DRAFT DECISION
Australian Gas Networks
Victoria and Albury gas access
arrangement
2018 to 2022

Attachment 6 – Capital
expenditure

July 2017

Figure 6.2 AGN's historical and forecast Tariff R and C connection volumes (Victoria and Albury)

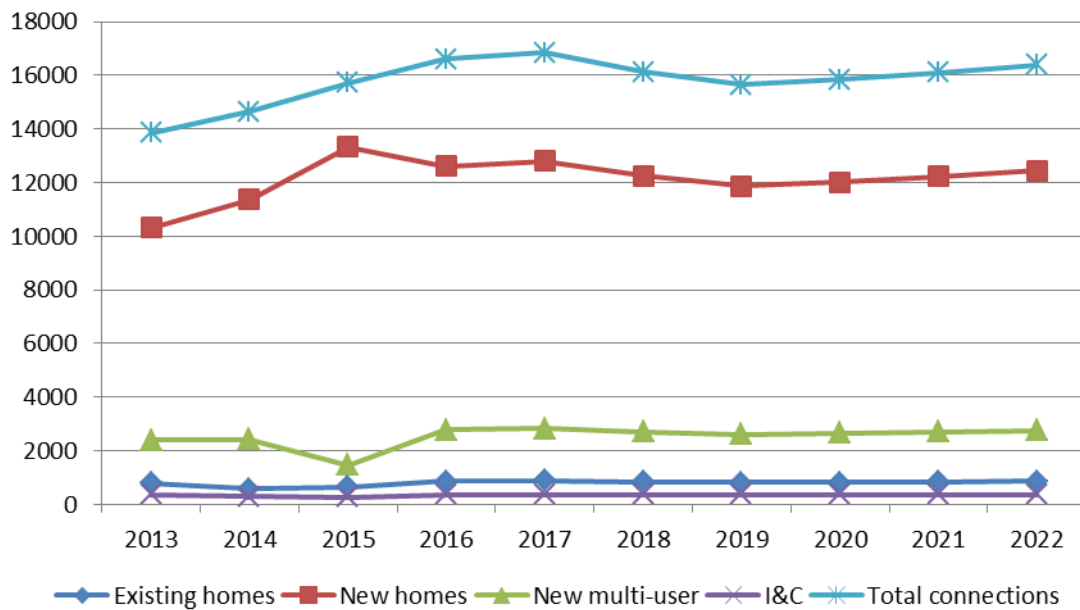
Figure 6.2 shows the historical trend and forecasts of AGN's new Tariff R and C connections at each connection category. Connections to new detached homes make up most new Tariff R connections and are forecast to recover following a decline in 2018 and 2019. Forecast volumes for medium density dwellings (apartments), existing homes, and Tariff C connections are also expected to remain stable.

AGN's proposal incorporates capex for its proposed joint marketing campaign for an additional 303 connections above CE's forecast.

As set out in Attachment 7, in this draft decision we do not accept AGN's forecast opex step change for this proposed marketing campaign. For capex, the impact of the proposed marketing campaign on AGN's proposed connections capex is 0.3 per cent.⁵³ Although this is immaterial in terms of the connections capex, we have adjusted for this in our alternative estimate for consistency with our decision on opex. However, as set out above, we consider this difference is immaterial at the overall level of proposed capex.

Subject to this adjustment, we are satisfied that AGN's forecast connection volumes are otherwise arrived at on a reasonable basis and the best forecast possible in the circumstances.⁵⁴
